# Service Bulletin S06KV

**Subject:** “MICO” Low Pressure Switch Shortened Service Life

**Models Affected:** 2006 Model Year Blue Bird All American model buses and 2006-2007 Model Year Blue Bird Vision Model Conventional Buses Equipped With Hydraulic Brakes and Option 40051 Door Brake Interlock

FIGURE 1  
(691 models)

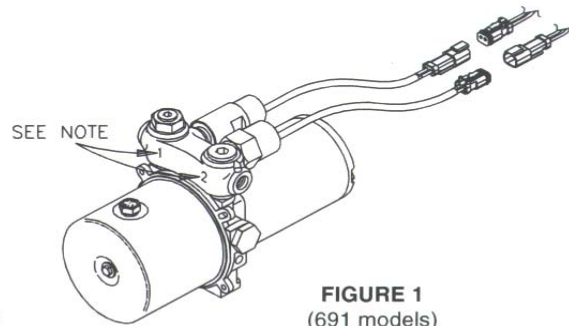
Regardless of manufacture date, the position of the high and low pressure switches have remained the same. See Figure 1, position 1 will always have a pressure switch stamped 1-800 and position 2 will always have a pressure switch stamped 2-10. Be sure to install the correct replacement switch.

1. Replace pressure switches as necessary and torque 17.6-23.1 N-m (13-17 lb-ft). **NOTE: Torque only on surface flats.**
2. **691 models:** Reattach wire connectors. See Figure 1.

FIGURE 2  
(earlier 690 models)

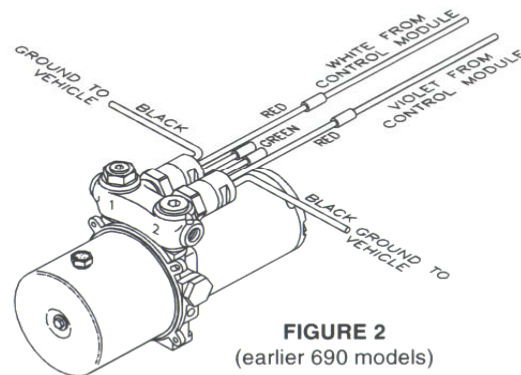
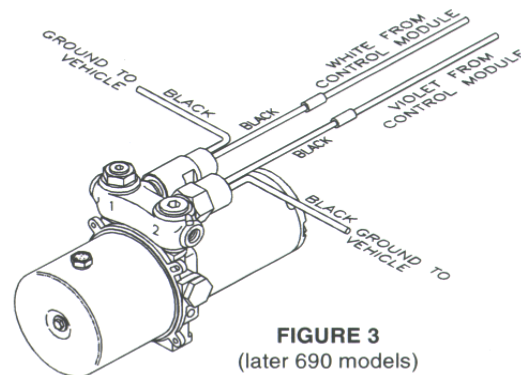
3. **690 models:** Earlier models of the 690 power unit provided a black wire, red wire, and green wire from each of the pressure switches as shown in Figure 2. These style switches are no longer available. Later models use pressure switches which provide two black wires from each as shown in Figure 3. When replacing pressure switches, either one of the black wires from each pressure switch can be used to connect to ground. Connect the other black wire from the pressure switches to the white wire or violet wire as shown in Figure 3. The pressure switch that connects to the white wire is stamped 1-800. The pressure switch that connects to the violet wire is stamped 2-10. **NOTE: Replacement switches may have connectors similar to FIGURE 1. Remove connectors as needed.**
